CLIENT NAME: PROJECT: 2022 SOUTH COBB DRIVE SE PARCEL ID# 1700000190 LAND LOT 300 17th DISTRICT COBB CO 2nd

PROJ. NO: 1340-001 DATE: 3-04-2015 SCALE: 1" = 40' DRAWN BY: DJD CHECKED BY: DGM SHEET TITLE: BOUNDARY SURVEY DRAWING NO: 1 OF 1

PETITION NO: Z-47

ZONING COMMENTS:

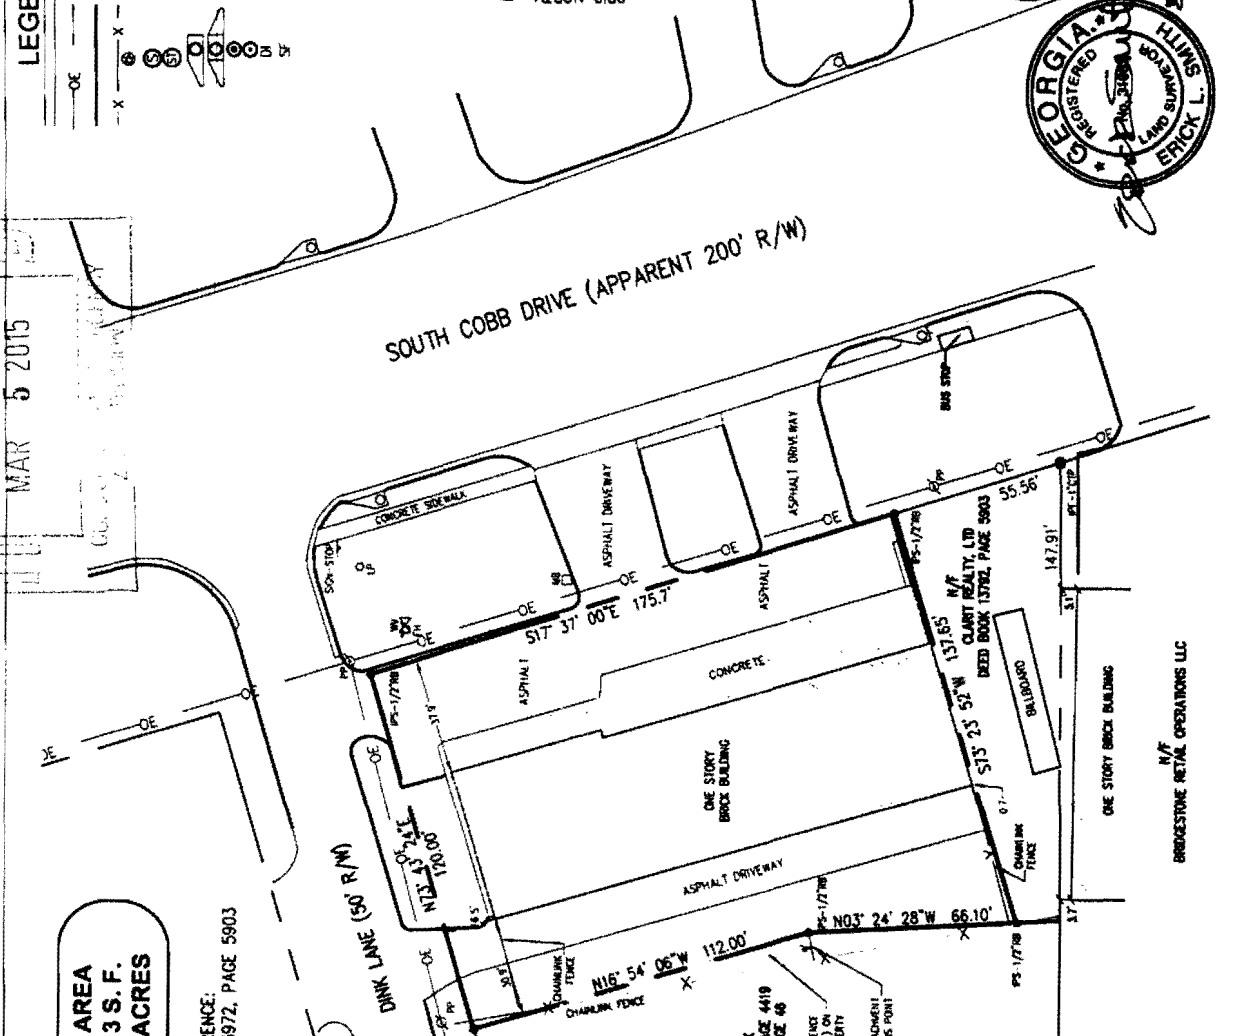
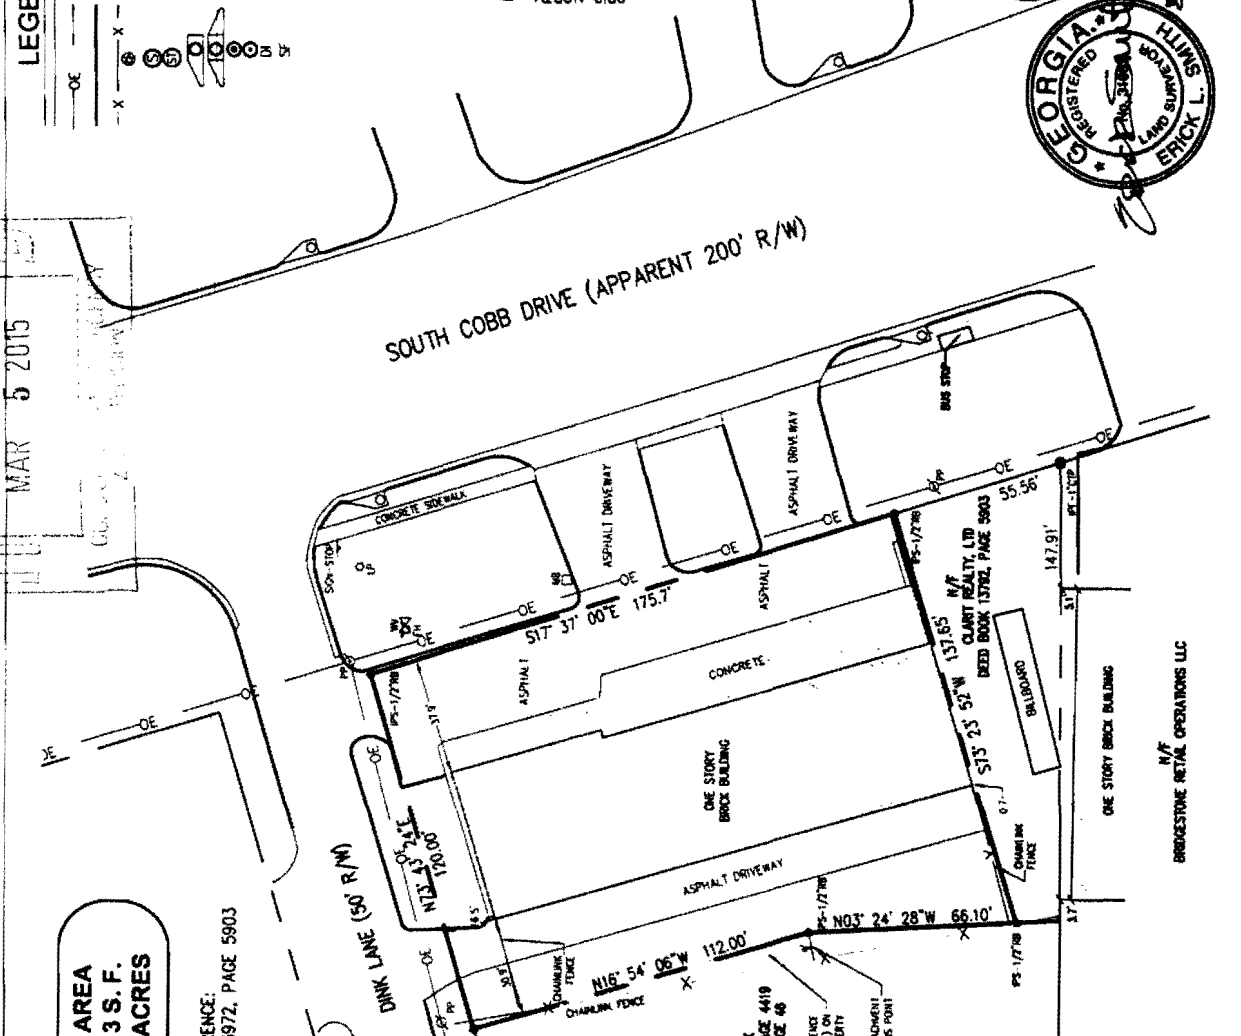
- No Stormwater controls shown _____
- Copy of survey is not current – Additional comments may be forthcoming when current site conditions are exposed.
- No site improvements showing on exhibit.

- B. It is Staff's opinion that the applicant's rezoning proposal may have an adverse affect on the usability of adjacent or nearby property. While the property had previously been used as an auto parts store, the existing building does not meet setback requirements, parking requirements and the property is over the allowed Floor Area Ratio (FAR).
